# ROCKY RIVER FISHWAY DIVERSION WALL 2019 COLINET, NEWFOUNDLAND PROJECT No. F6879-191003 ISSUED FOR 99% REVIEW

revisions	ISSUED FOR 99% REVIEW	19/07/12
project	<b>ROCKY RIVER FISHWAY DIVERSION WALL 2019</b>	
designer	<b>COLINET NEWFOUNDLAND</b>	
drawing	<b>EXISTING SITE PLAN WITH DEMOLITION</b>	
designed	C. FISHER	concu
date	JULY, 2019	
drawn	P. MARSH	dessine
date	JULY, 2019	
approved		approuve
date		
Tender		Soumission
DFO Project Manager	Administrateur de projets MPD	
project number	no. du projet	
	<b>F6879-191003</b>	
drawing no.	no. du dessin	
	<b>C1 OF 4</b>

revisions	A	ISSUED FOR 99% REVIEW	19/07/12
project	ROCKY RIVER FISHWAY DIVERSION WALL 2019		
client	COLINET NEWFOUNDLAND		
drawing	NEW SITE PLAN		
designed	C. FISHER	concu	
date	JULY, 2019		
drawn	P. MARSH	dessine	
date	JULY, 2019		
approved		approuve	
date			
Tender		Soumission	
DFO Project Manager	Administrateur de projets MPO		
project number	F6879-191003		
drawing no.	C2 OF 4

**1 2 NEW SITE PLAN**  
 SCALE: 1:100

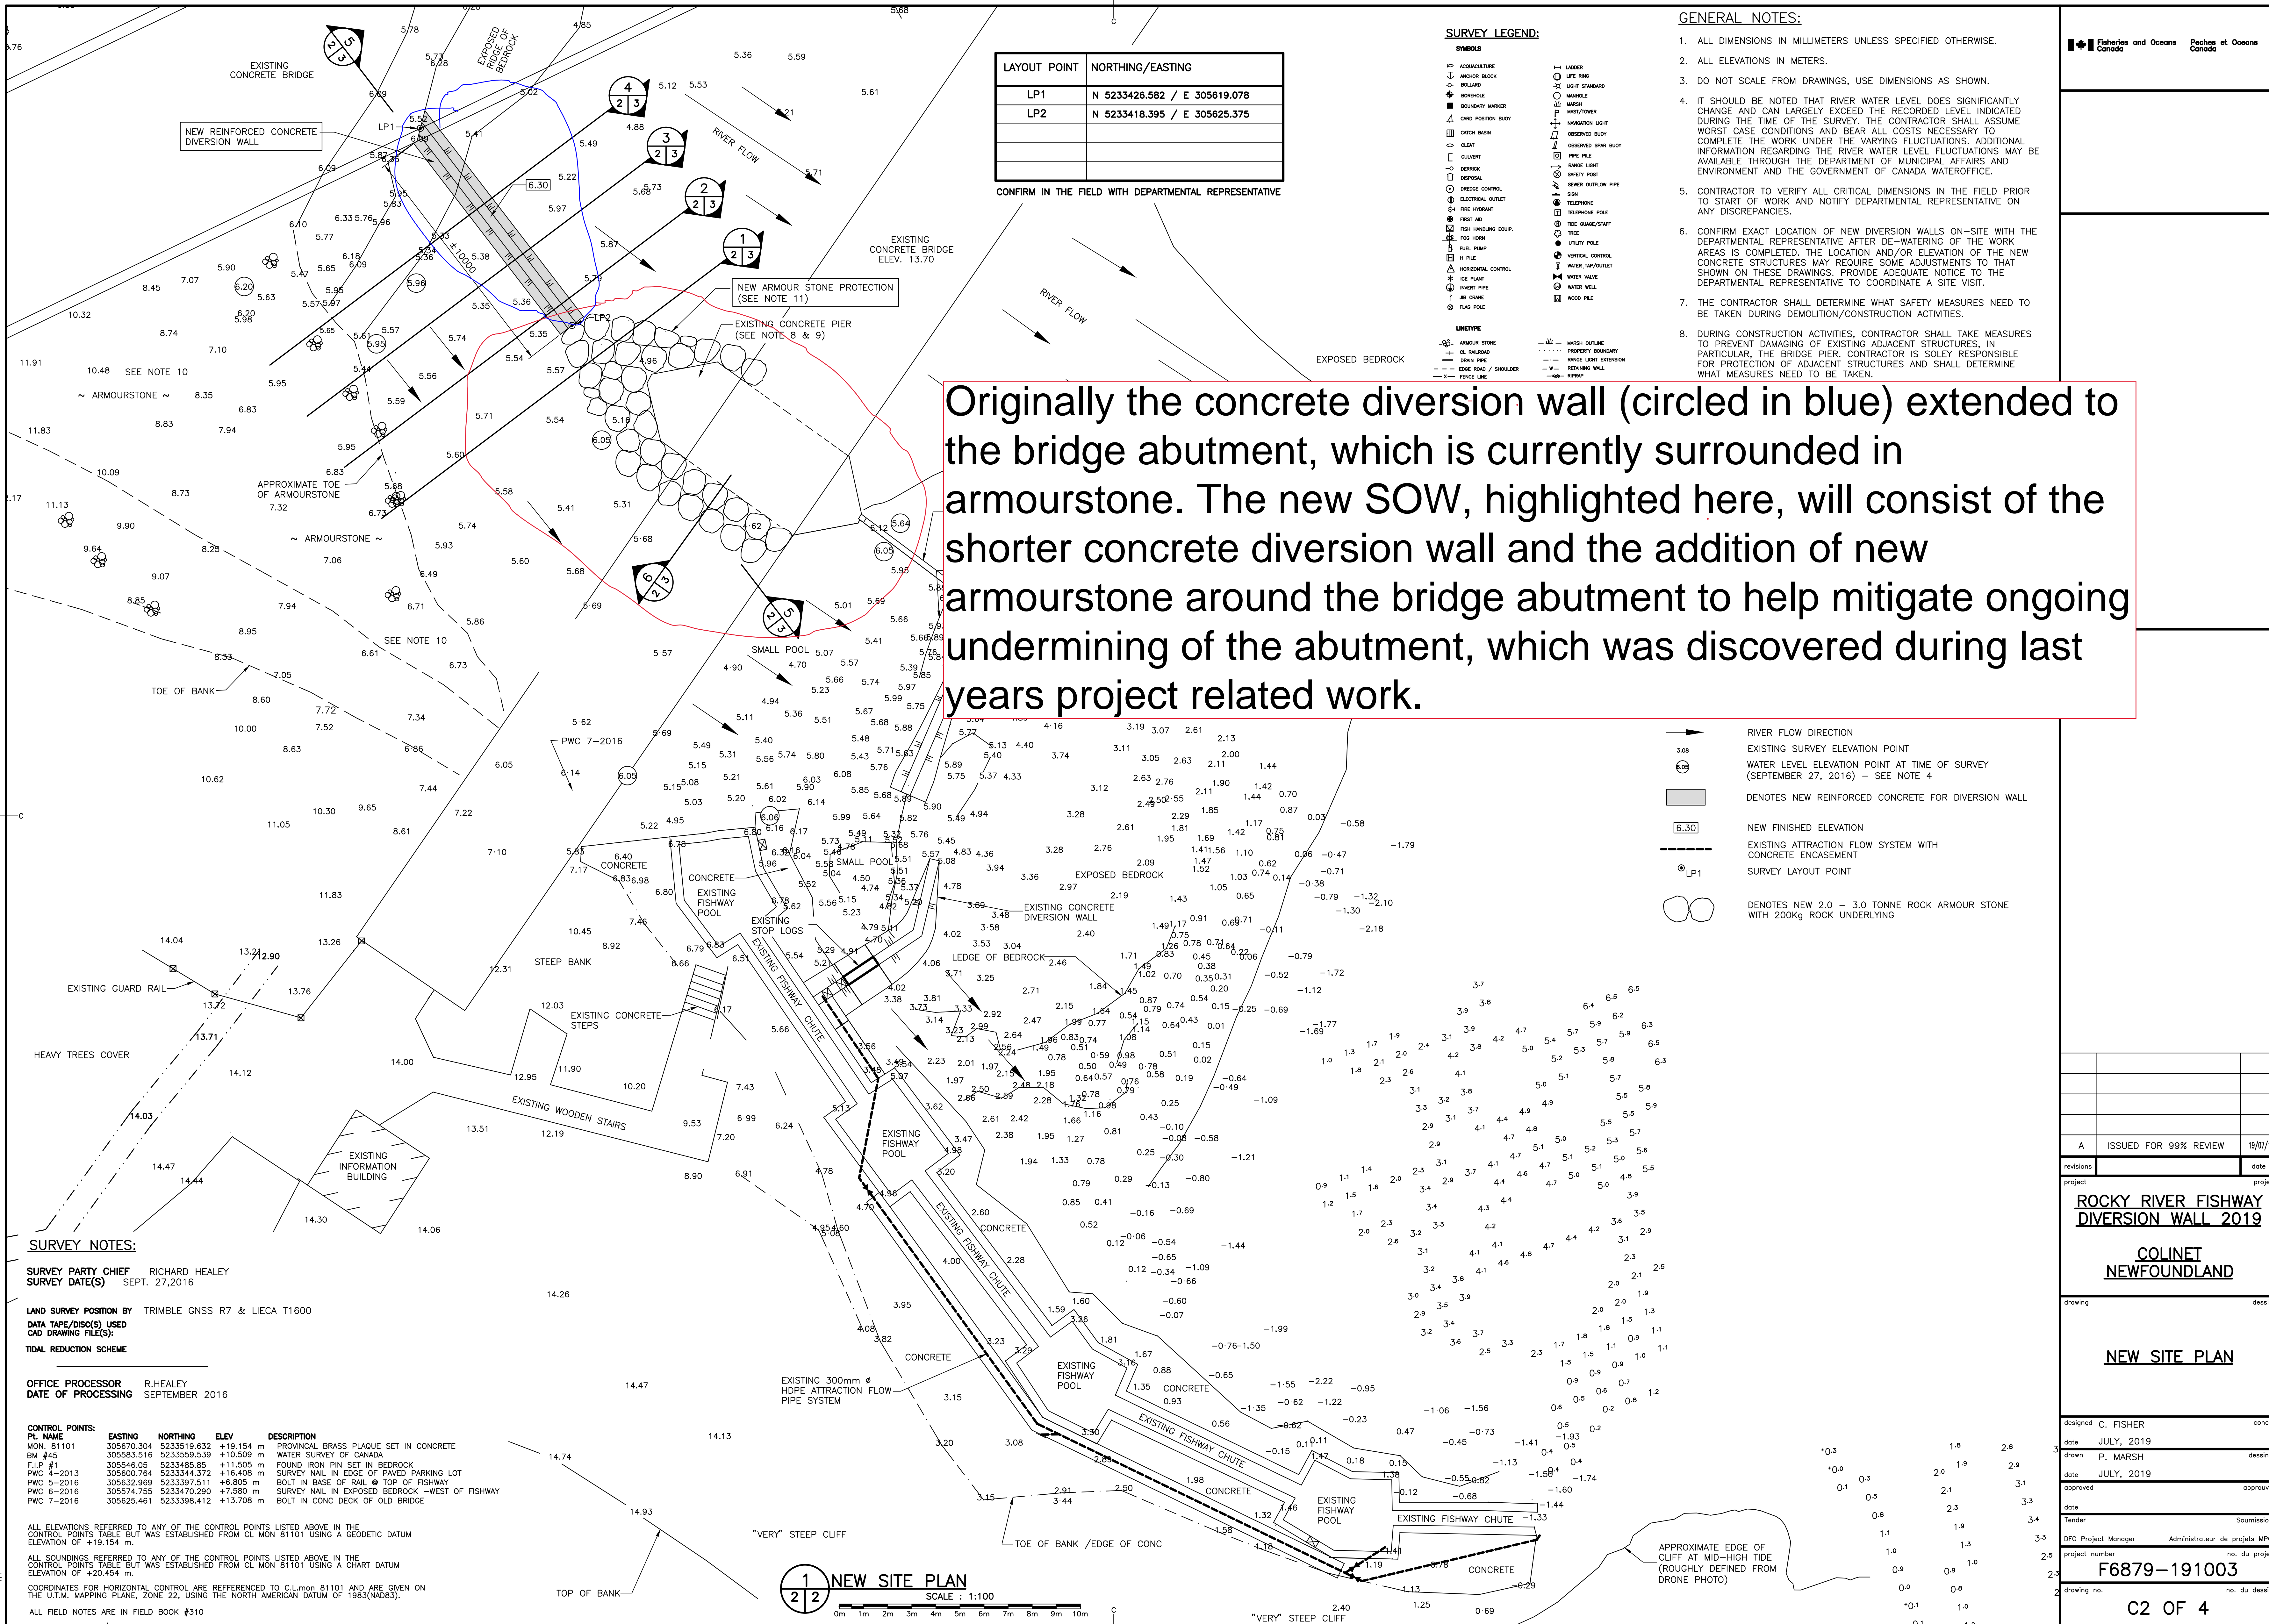
Originally the concrete diversion wall (circled in blue) extended to the bridge abutment, which is currently surrounded in armourstone. The new SOW, highlighted here, will consist of the shorter concrete diversion wall and the addition of new armourstone around the bridge abutment to help mitigate ongoing undermining of the abutment, which was discovered during last years project related work.
